PRATT & WHITNEY CANADA  
**SERVICE BULLETIN**

P&WC S.B. No. 41123

TURBOSHAFT ENGINE  
SEAL BLADE PLATFORM - REPLACEMENT OF

**PT6C-72-41123**  
Cover Sheet

Compressor Turbine Disk Balancing Assembly - Parts Progression  
Figure 1

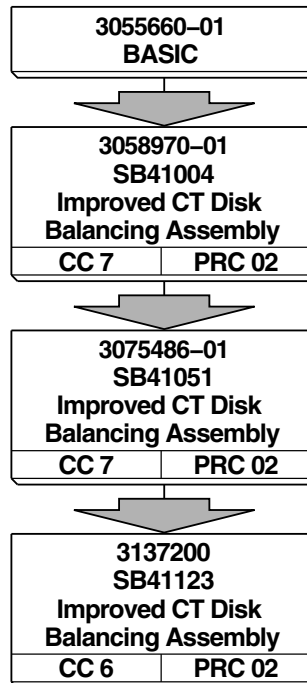
The blade platform seal can interfere with the turbine blade under-platform pocket.

The blade platform seal is not optimal.

Replace the blade platform seal with one including maximum dimension requirements.

Refer to Figure 1 for parts progression.
